**ADDENDUM 2**

Contract: 22-C-00044; Hyde Park Groundwater Diversion Underdrains

**Hyde Park Groundwater Diversion Underdrains  
Responses to Bidder Questions  
2/22/23**

SHEET  
3  
OF 14

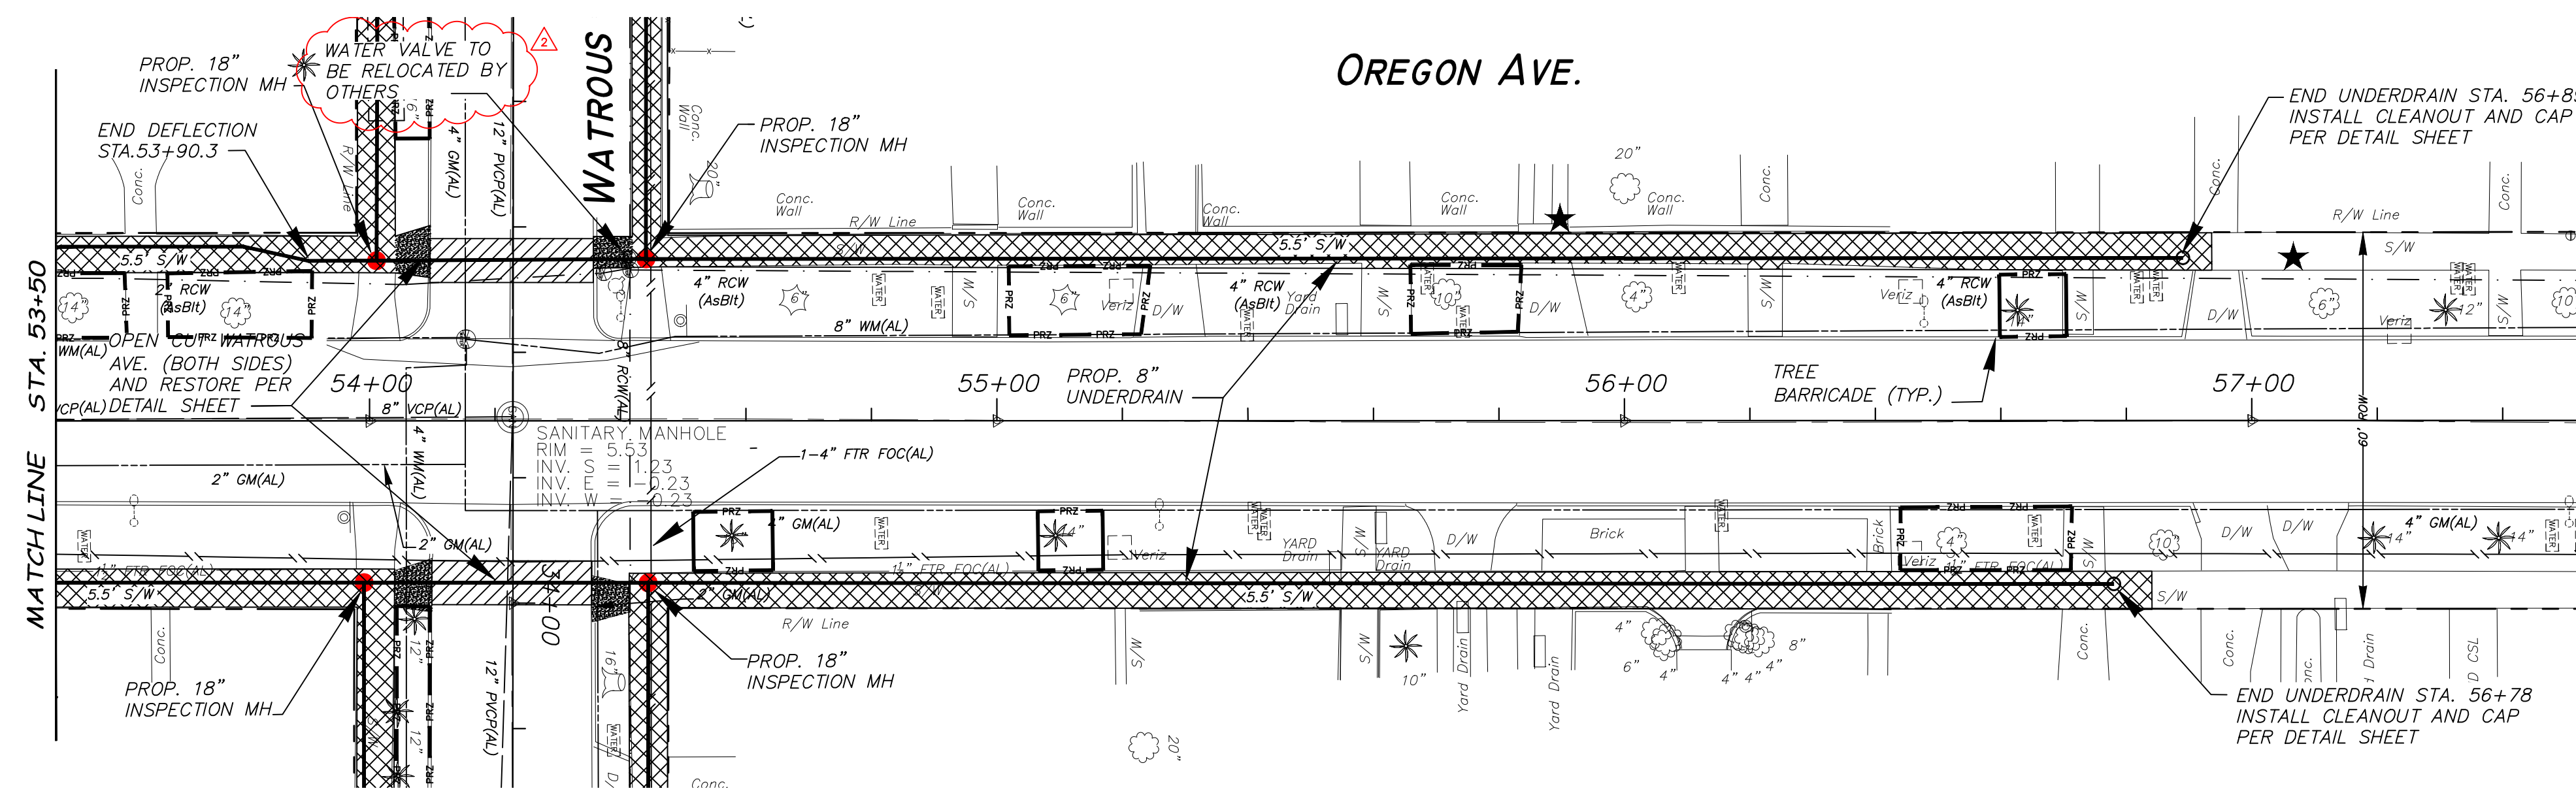
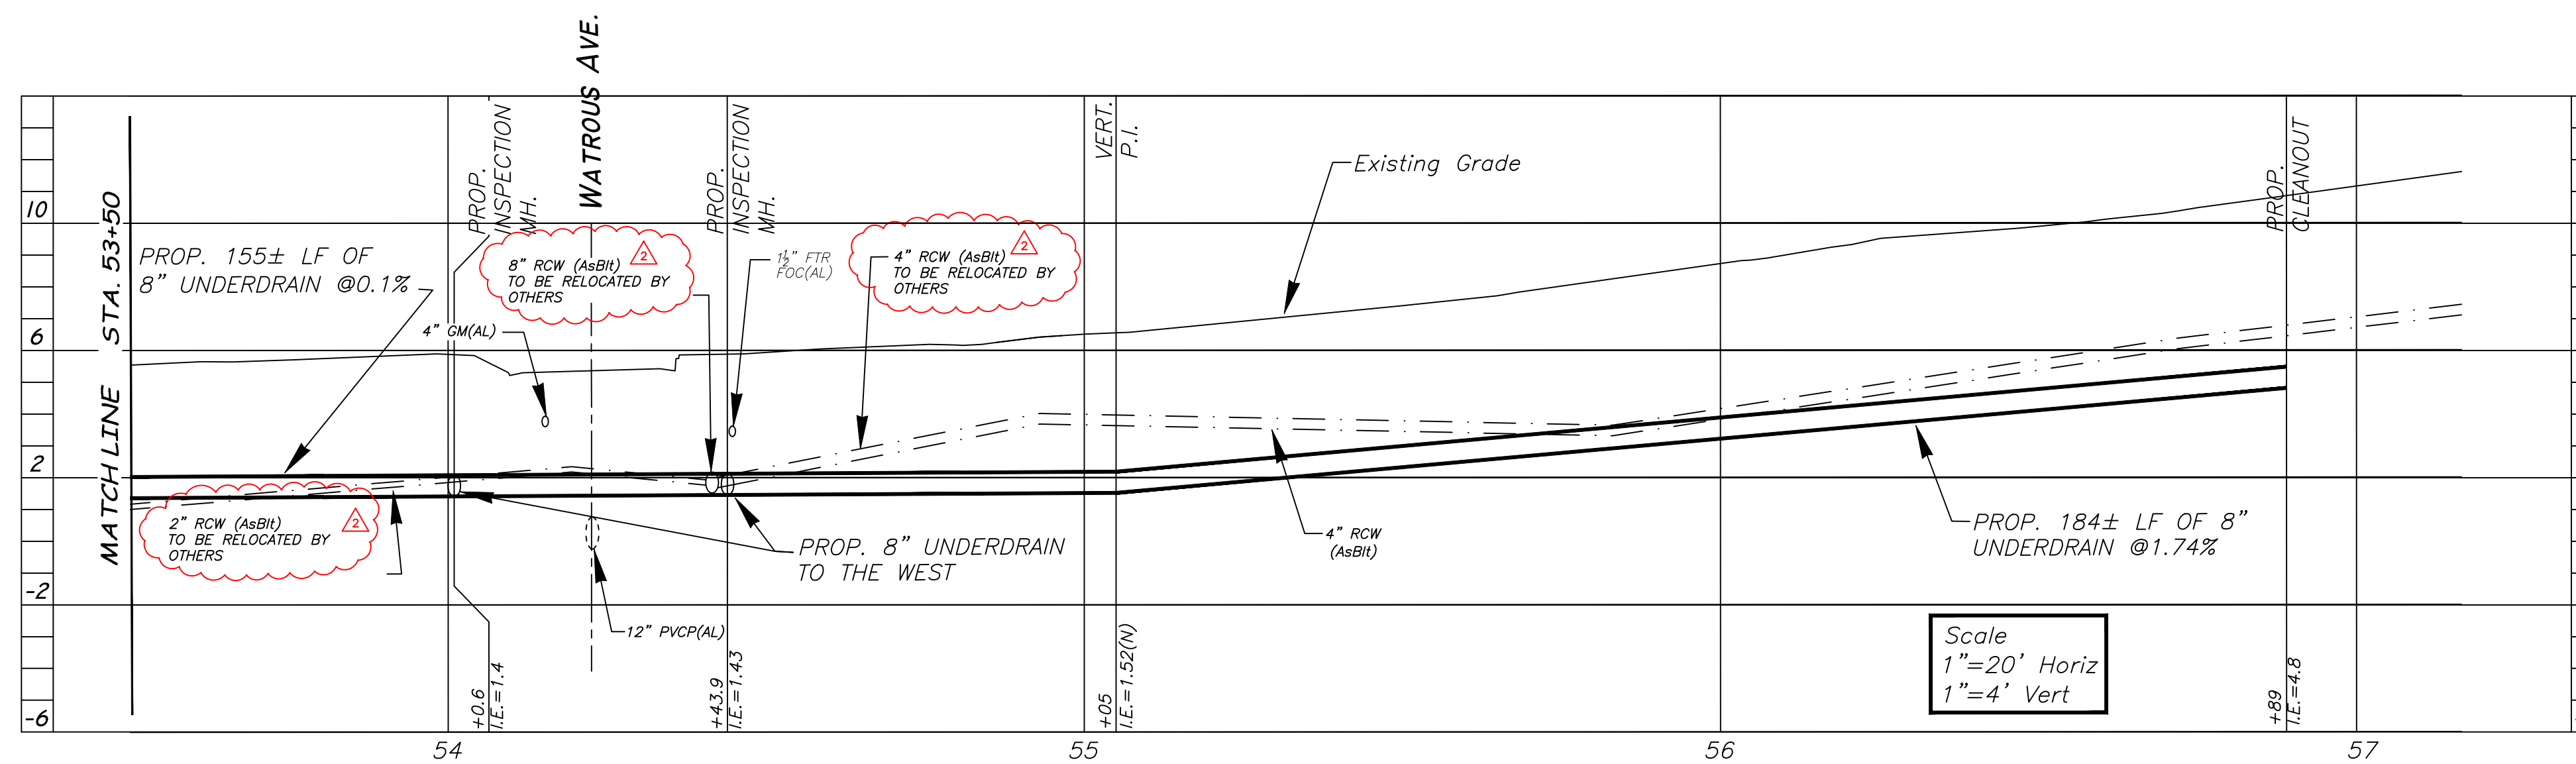
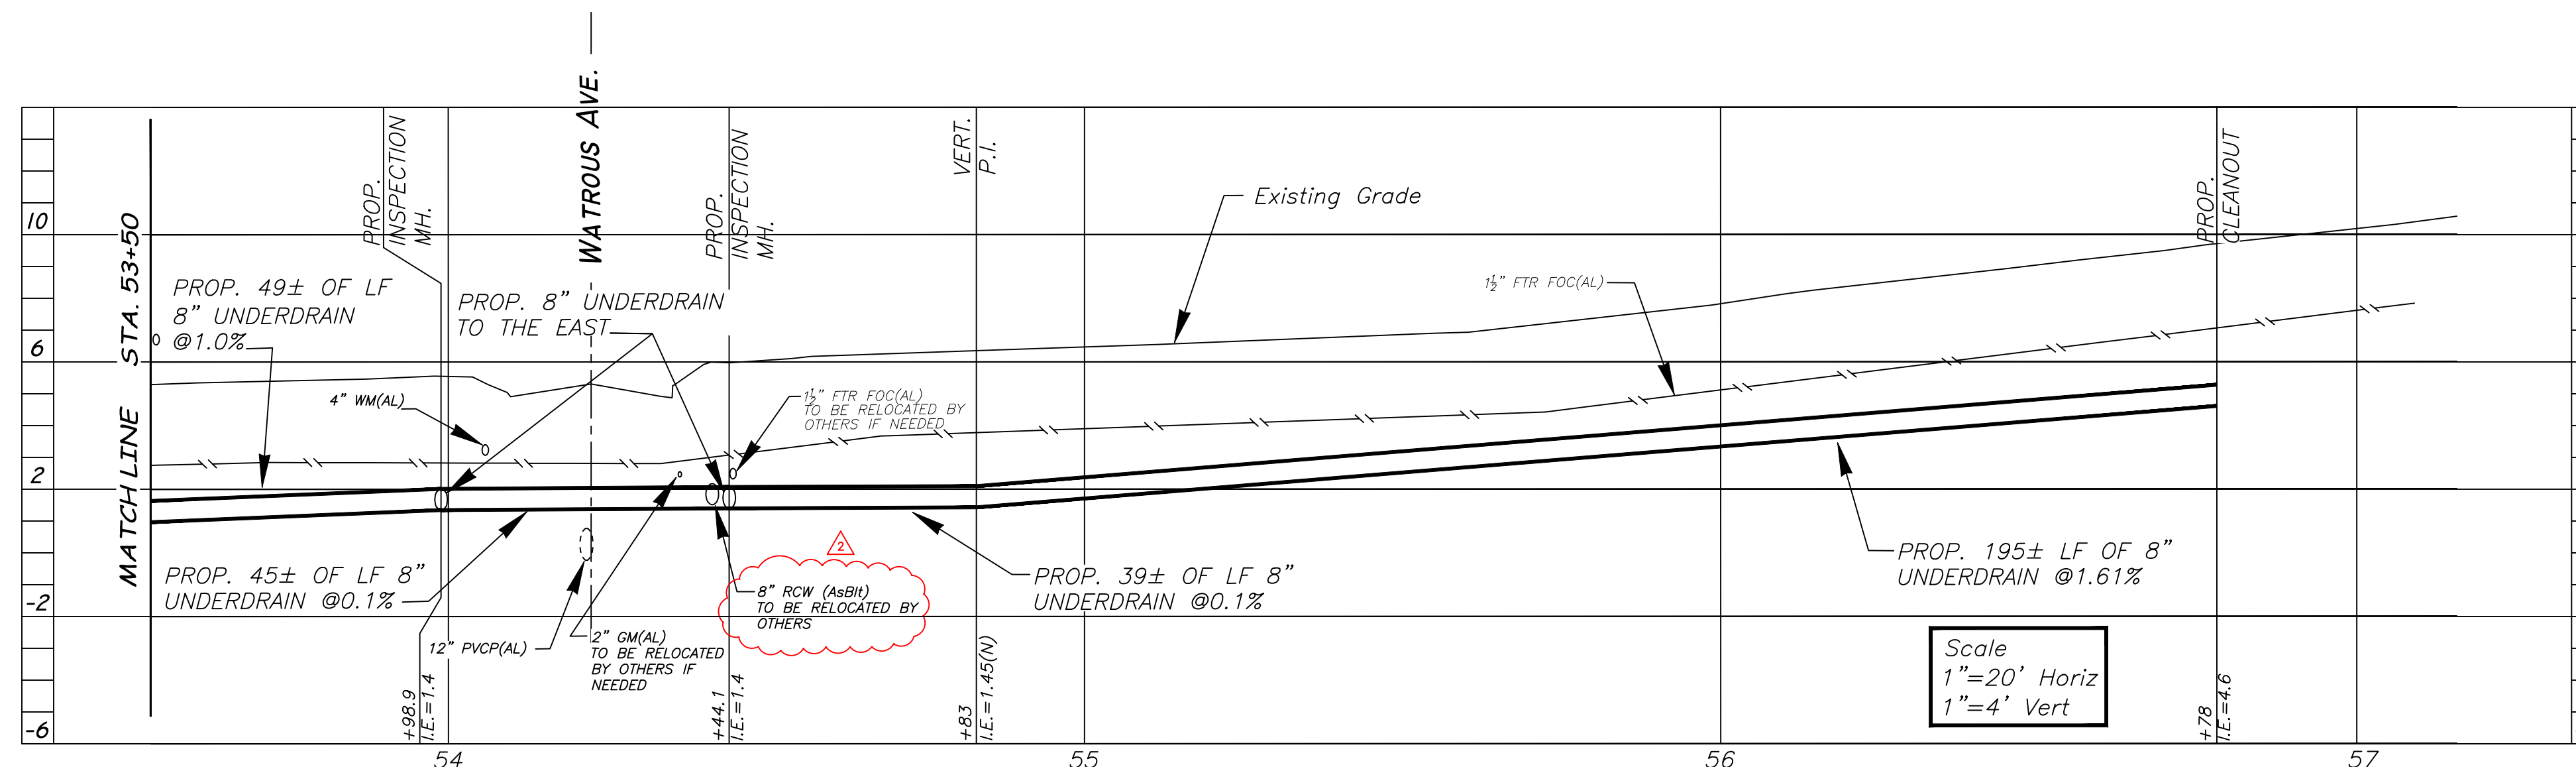
1. Your plan sheets call out "Jack & Bore" (Sheet #3) but you have you have no Jack & Bore Bid items. Are these "Jack & Bore" Locations where you bid item #0440-30 8" HDPE Directional Bore is supposed to go?

**Response:** Yes
